**WHITE PLAINS CITY SCHOOL DISTRICT
AC AND VENTILATION UPGRADES AT
MAMARONECK AVENUE ELEMENTARY SCHOOL
SED Control Number: 66-22-00-01-0-010-017**

**CONTRACT H- HVAC WORK
CONTRACT E - ELECTRICAL WORK**

End of Addendum No. 2

DRAWING No.
E 100.00

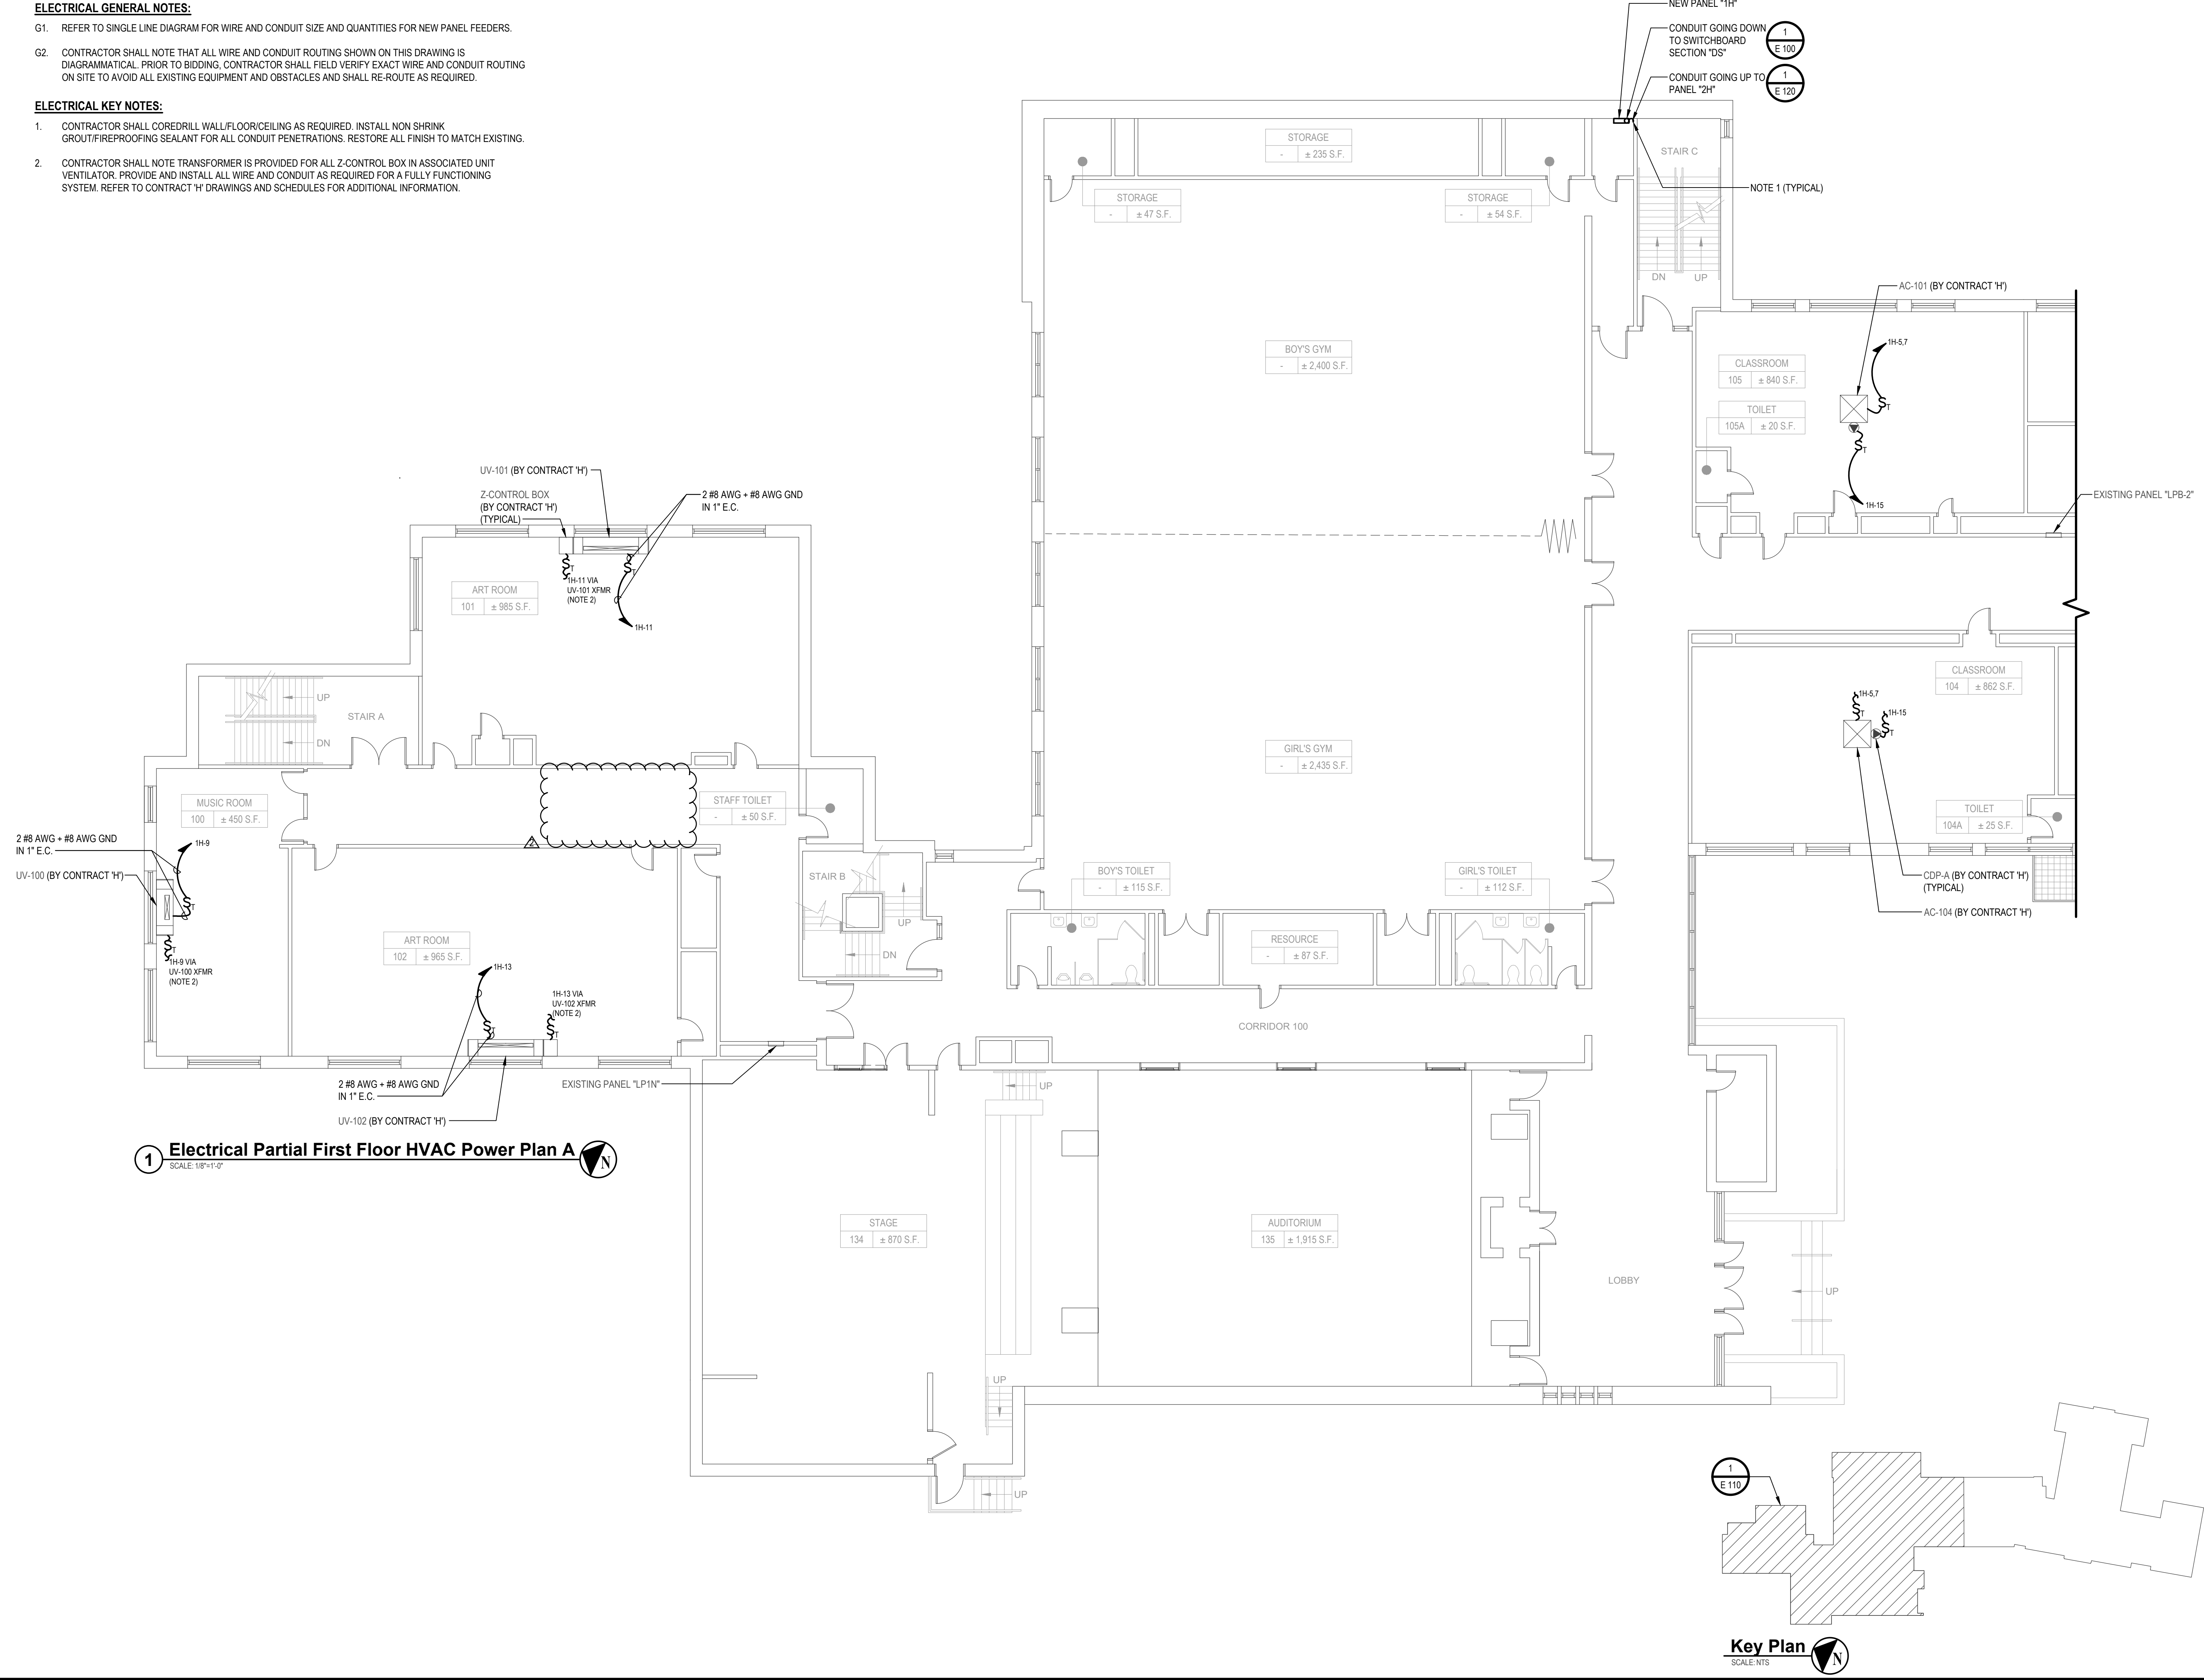
1. As part of DRAWING E101.00, Contract 'E' shall include in Base Bid the removal and reinstallation of existing the stair railing as necessary to accommodate delivery and installation of new switchgear and associated equipment. Contractor shall provide all material and labor to restore railing and stair to match existing.
